Notice of Intent

Sundry ID: 2734751

Type of Submission: Notice of Intent	Type of Action: Plug and Abandonment
Date Sundry Submitted: 06/07/2023	Time Sundry Submitted: 10:00
Date proposed operation will begin: 07/01/2023

Well: Canyon #1

P&A Proposed Schematic

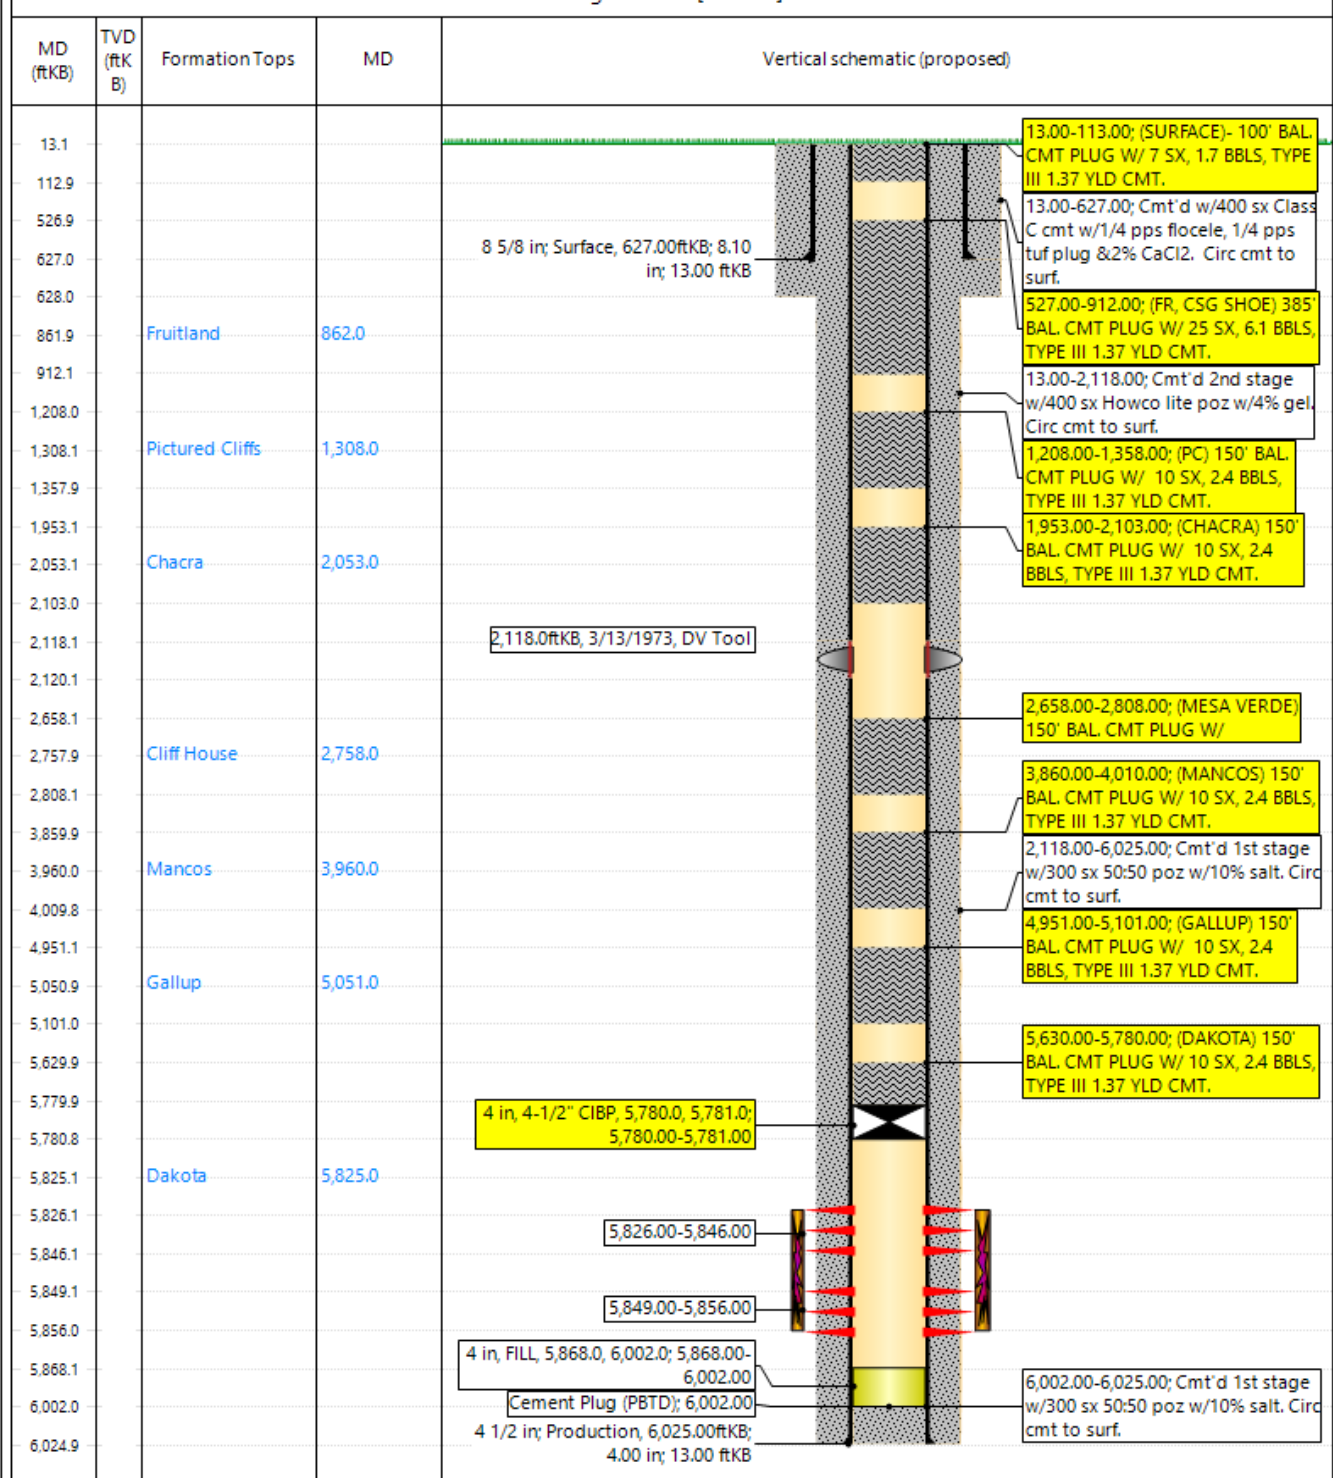
Please Add a cmt
plug sufficient to
cover the DV tool
@ 2118'

1. Plugging operations authorized are subject to the attached "General Requirements for Permanent Abandonment of Wells on Federal and Indian Lease."
2. The following modifications to your plugging program are to be made:
 - a. Adjust Plug #2 (Gallup) to cover BLM formation top pick @ 4794'.
3. Farmington Office is to be notified at least 24 hours before the plugging operations commence at (505) 564-7750.

- Adjust Plug #2 (Gallup) to cover BLM formation top pick @ 4794'.

Created By	Condition	Condition Date
john.harrison	Accepted for record - NMOCD JRH.6/15/23. BLM approved P&A 6/9/23. Please add cmt plug sufficient to cover DV Tool @ 2118'	6/15/2023
